**Engineering Review**

**PRELIMINARY DRAINAGE REPORT  
FOR  
STERLING RANCH PHASE 2 PRELIMINARY PLAN**

**May, 2021  
Project No. 25188.02  
SP-20-003**

## INLET IN A SUMP OR SAG LOCATION

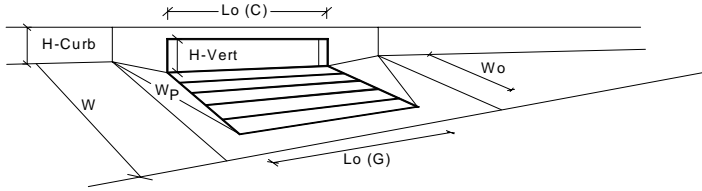
If this is intentional provide the overflow conveyance design and show on the drainage plan. Add a short description on this sheet.

Scenario: 100 Year

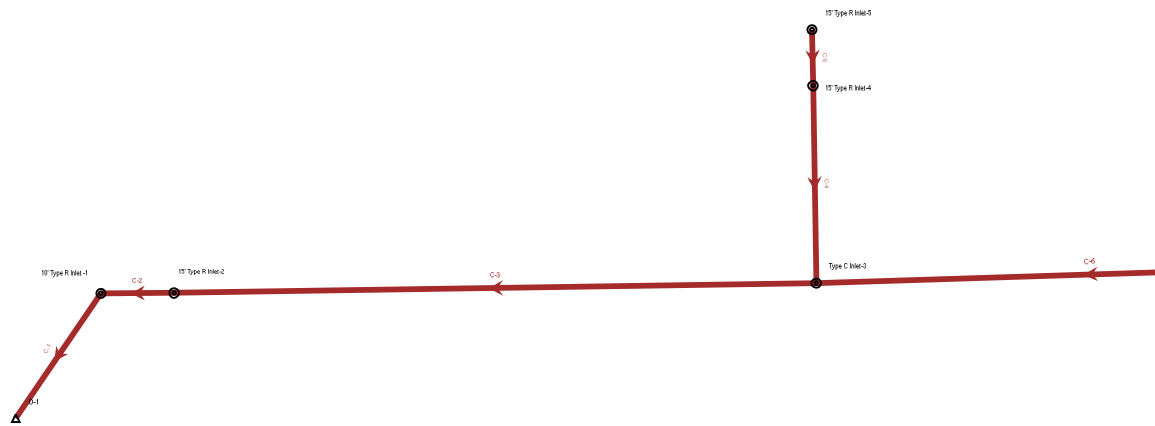
Interim condition?

← Also provide final condition

# Scenario: 100 Year

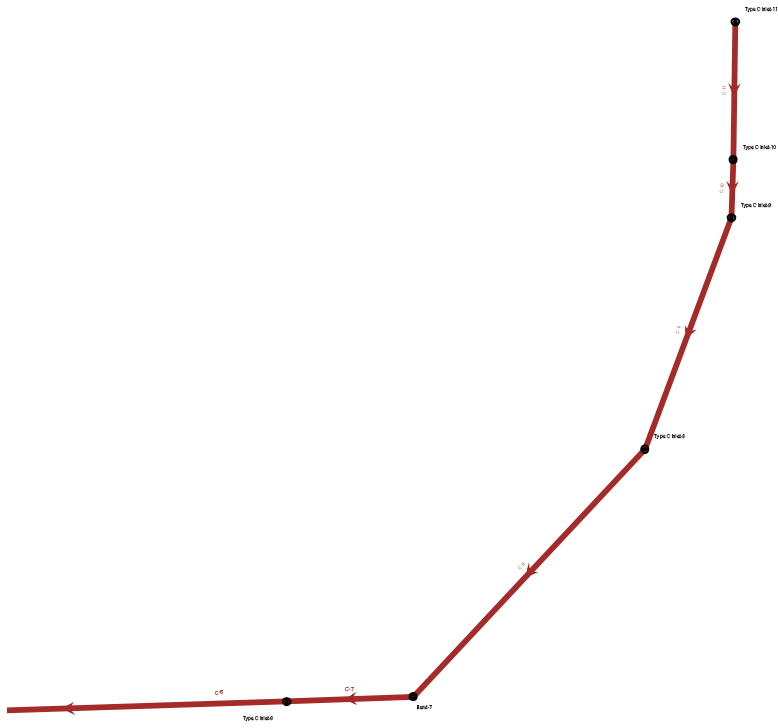
Provide calculations for the "C" basins also - inlets 5 and 6 to MH 7.1 and DP4 to MH7.1.
